CONTRACT 26016

Building and Site Improvements at 6741 Downing Avenue, Bakersfield, CA

Bidder's Request for Information Responses #3

July 7, 2026

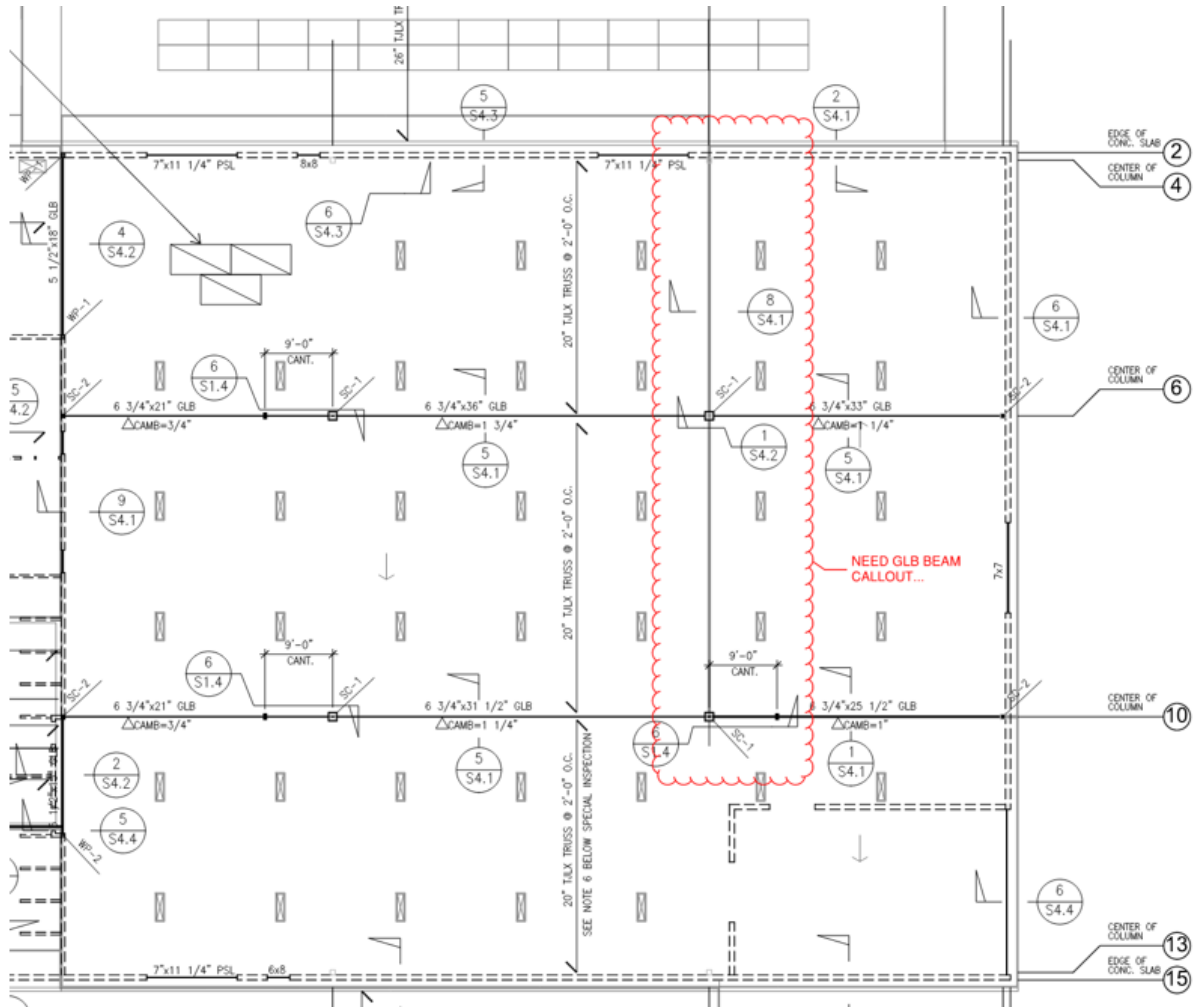
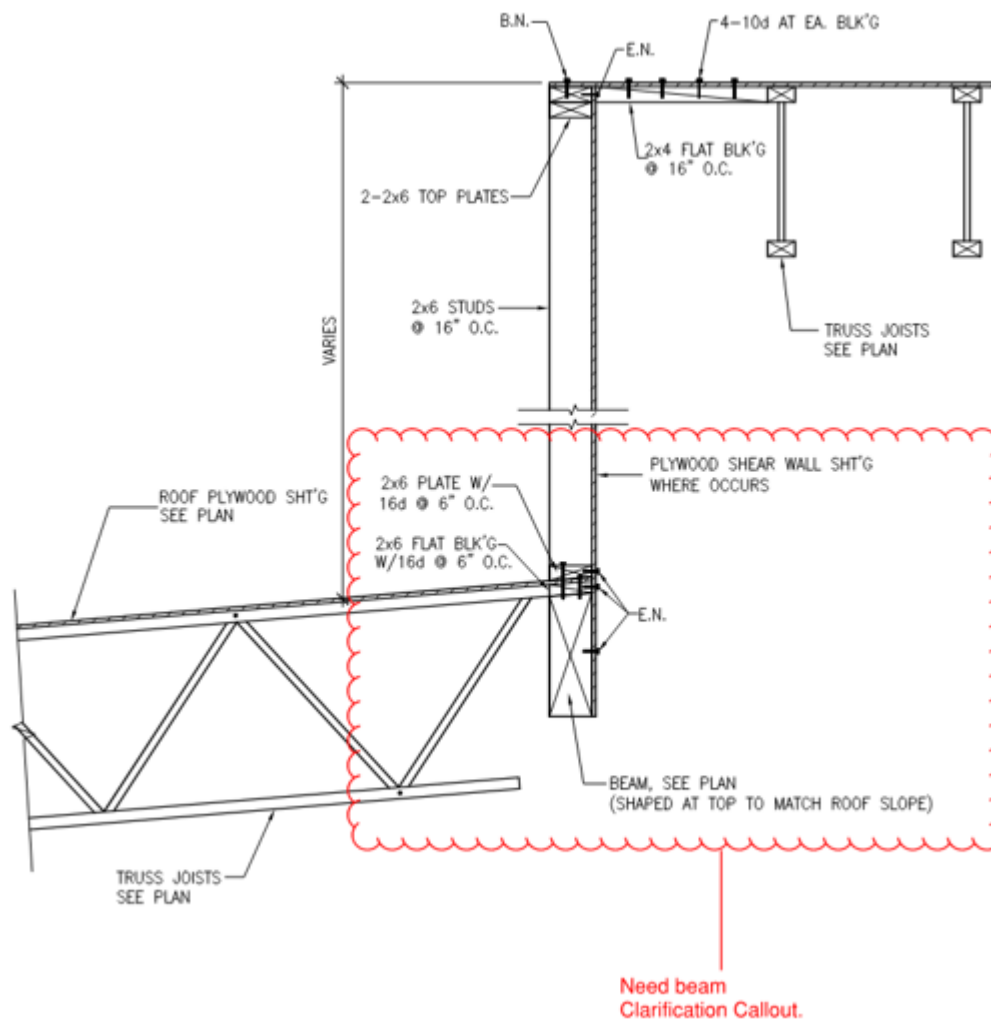
What color/texture block is to be used for the concrete parking garage?

CMU blocks for the parking garage shall be split-face with a light-gray texture. This information has been included on sheet A700A under an addendum.
